IREDELL COUNTY HEALTH DEPARTMENT

IMPROVEMENT PERMIT / AUTHORIZATION TO CONSTRUCT / OPERATION PERMIT / EXISTING SYSTEM INSPECTION

PERMIT# ~~13267~~ 14932 PIN# 4615991188.000 DATE 8/14/07

ADDRESS 395 BARBER LOOP MOORESVILLE NC 28115

INITIAL SITE SKETCH

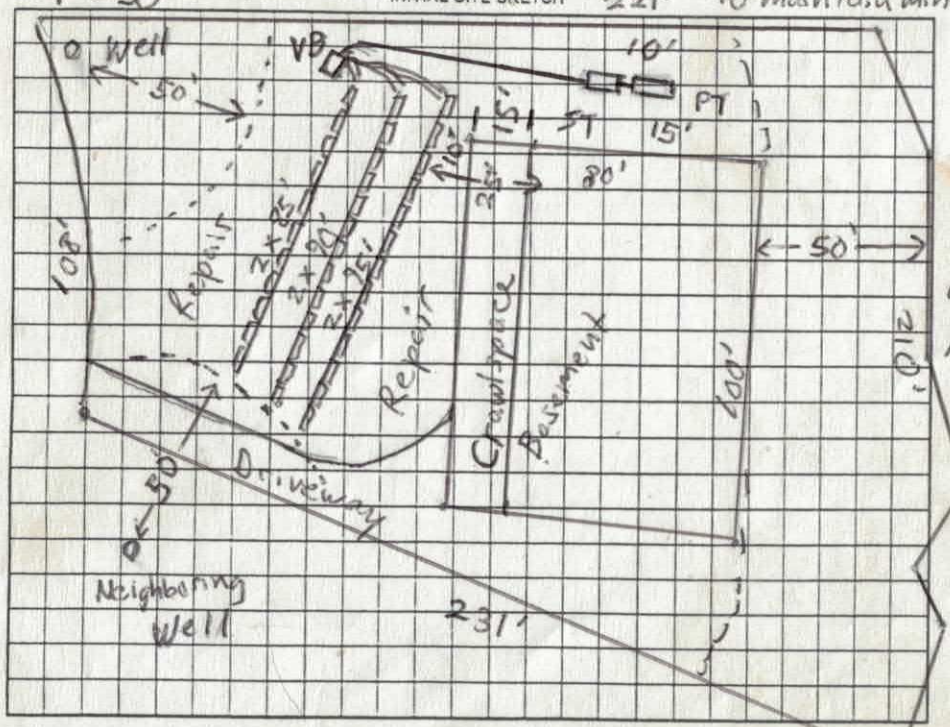
Comments:/Conditions: * Must stay 25' min from basement with up slope drainfield, House will be min. 15' crawl space in front b/c starting basement or the house must be smaller and set min. 15' further back 221' to maintain min. 25' separation.

1/4/08 Reviewed Plans, essentially same as I.P. A.C.

10/6/08 V. sited site for tank final found 2-3' of fill Told Installer they have to remove fill in drainfield area b/f Installation. A.C.

CRAWL SPACE AREA

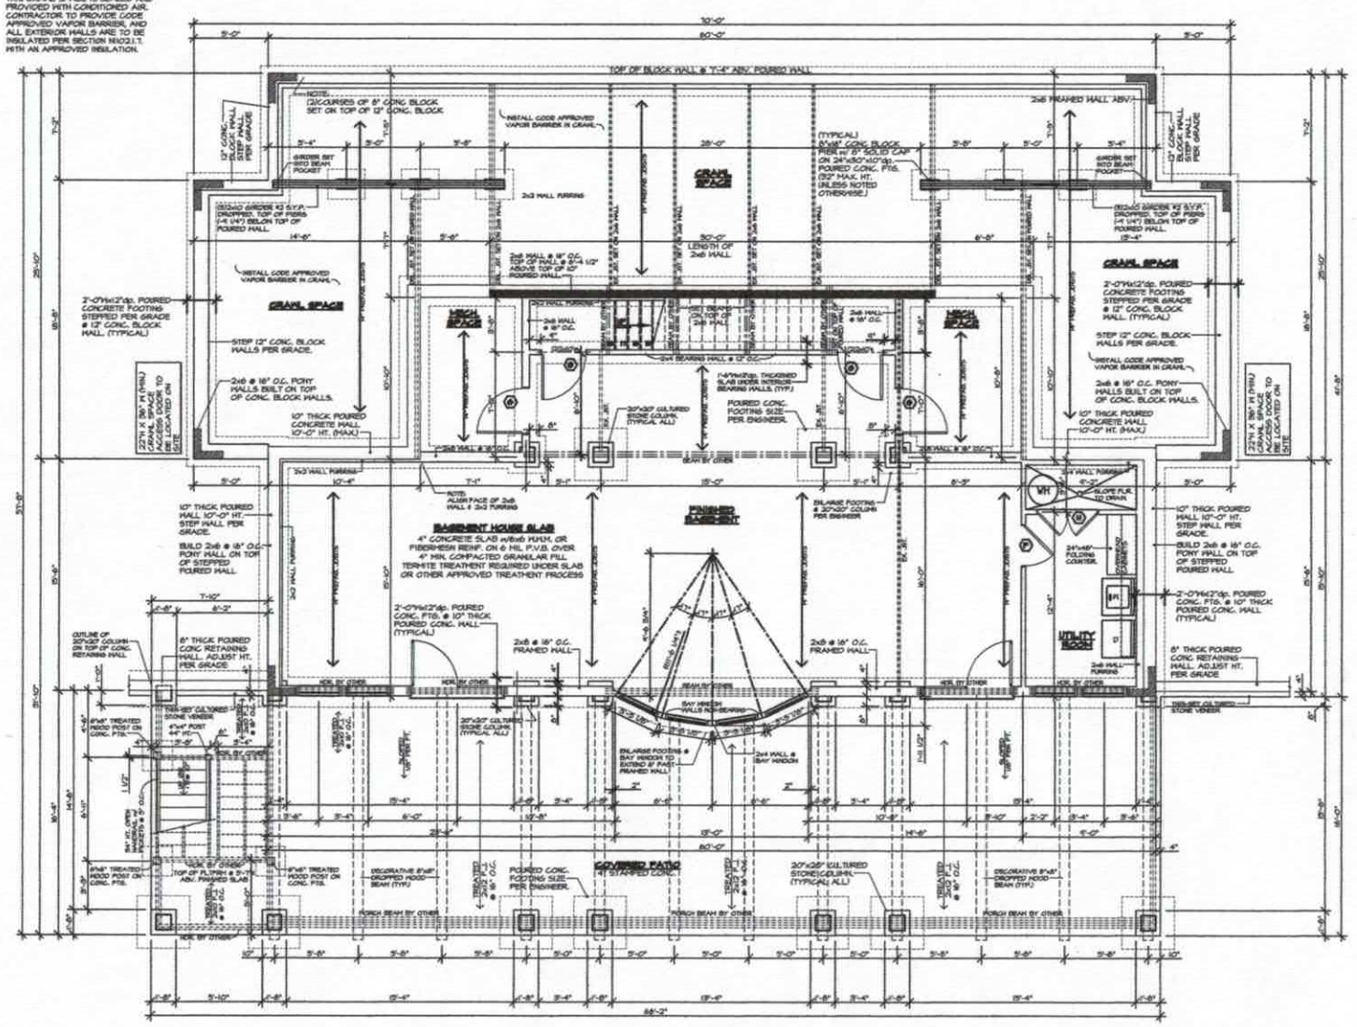
Acknowledgement Of
Plans Submittal ONLY!
Date 1/4/08
Date 1/4/08
